STATE OF OREGON
DEPARTMENT OF ENVIRONMENTAL QUALITY

PROPOSED SUBSURFACE SEWAGE DISPOSAL SYSTEM

PLOT PLAN

521 Ocean Ave

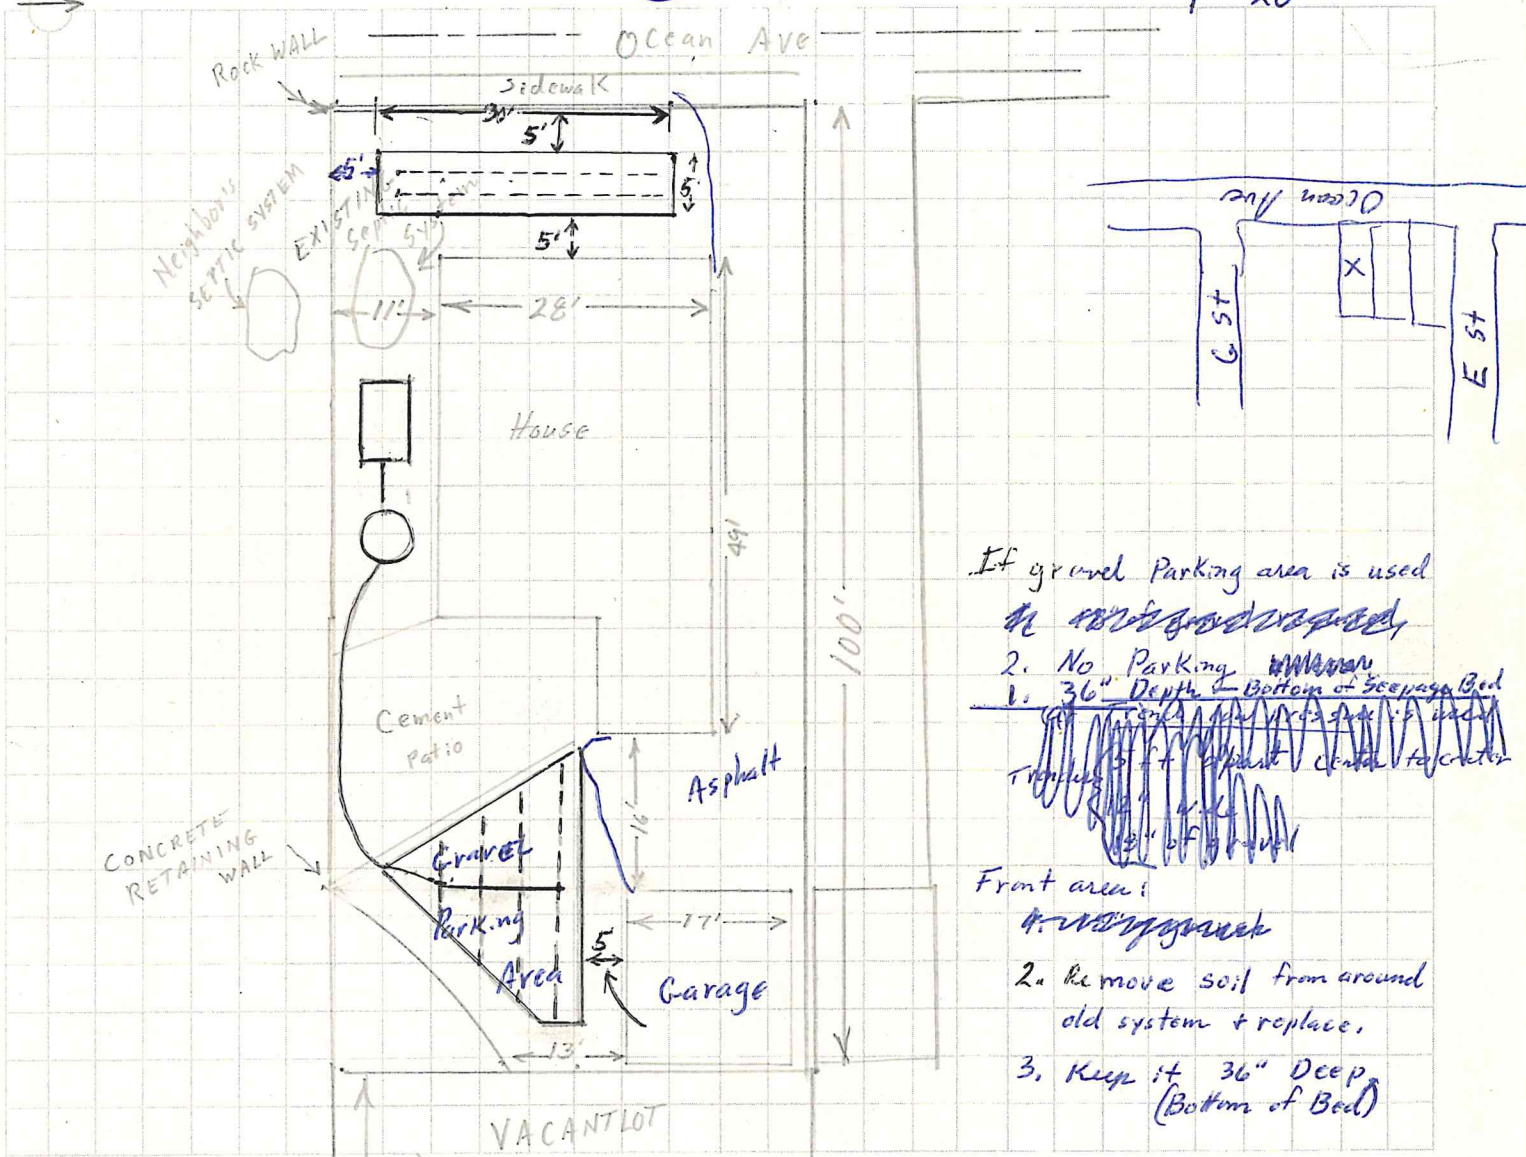
If gravel parking area is used
 1. No parking ~~in~~
 2. 36" Depth Bottom of seepage bed
 3. ~~front area pressure is in~~
 4. ~~front area pressure is in~~
 5. ~~front area pressure is in~~
 6. ~~front area pressure is in~~
 7. ~~front area pressure is in~~
 8. ~~front area pressure is in~~
 9. ~~front area pressure is in~~
 10. ~~front area pressure is in~~
 11. ~~front area pressure is in~~
 12. ~~front area pressure is in~~
 13. ~~front area pressure is in~~
 14. ~~front area pressure is in~~
 15. ~~front area pressure is in~~
 16. ~~front area pressure is in~~
 17. ~~front area pressure is in~~
 18. ~~front area pressure is in~~
 19. ~~front area pressure is in~~
 20. ~~front area pressure is in~~

- Front area:
1. ~~front area pressure is in~~
 2. Remove soil from around old system + replace.
 3. Keep it 36" Deep (Bottom of Bed)

Send me a plot plan
 of what version you
 intend to use.
 I recommend gravel
 parking area. ~~as shown~~

Neighbor on South had septic tank
 pumped frequently when his children
 were at home.
 He is living alone now and has
 no problems with it
